Engineering Review

PCD-ENGINEERING REVIEW COMMENTS
IN BLUE BOXES WITH BLUE TEXT

**DRAINAGE LETTER
FOR
STERLING RANCH ROAD
CROSSING OF SAND CREEK**

PCD Project No. CDR-226

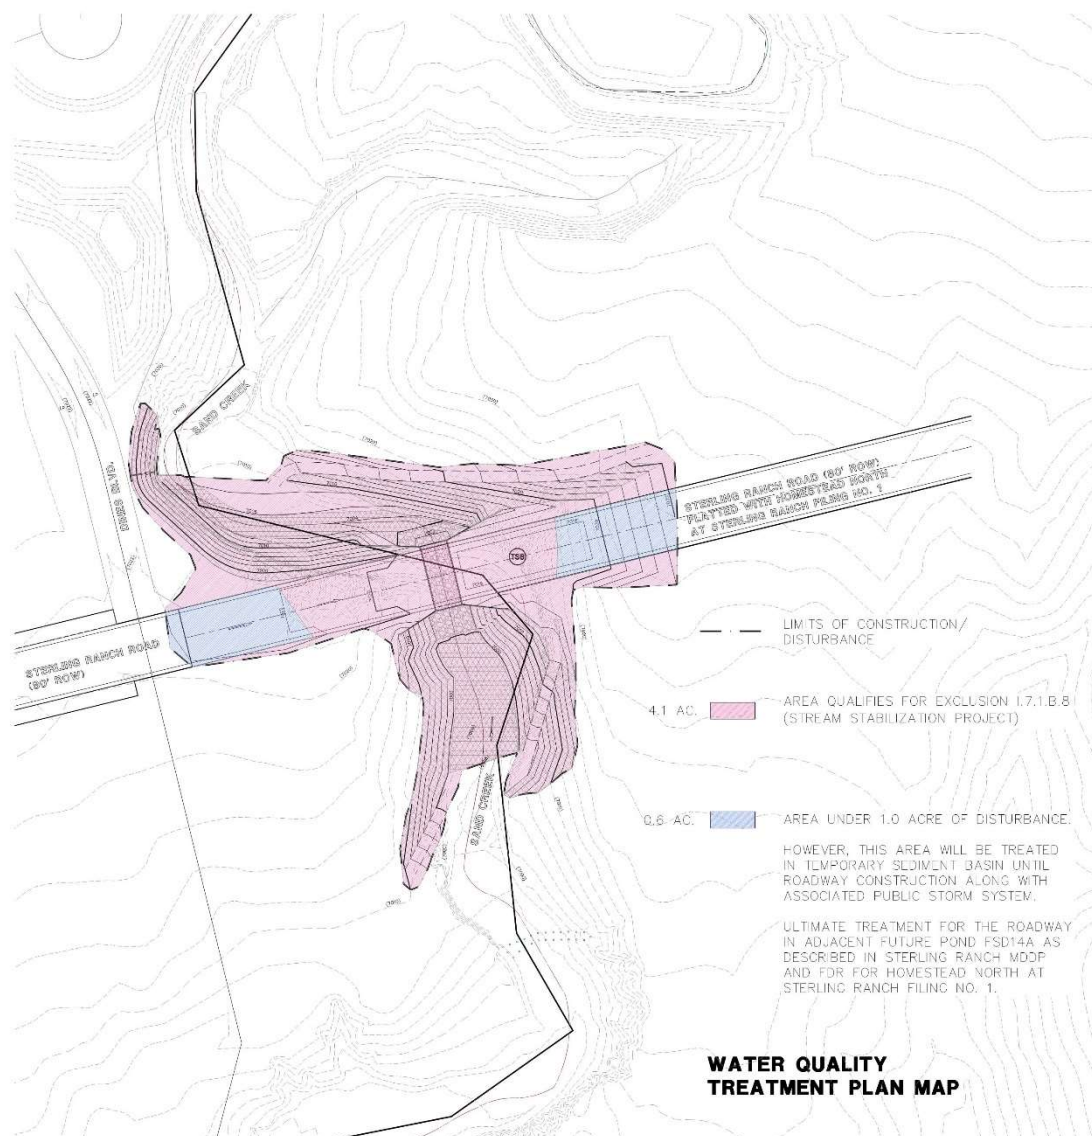
State that the roadway improvements will convey runoff to WQ facilities.

Added to narrative
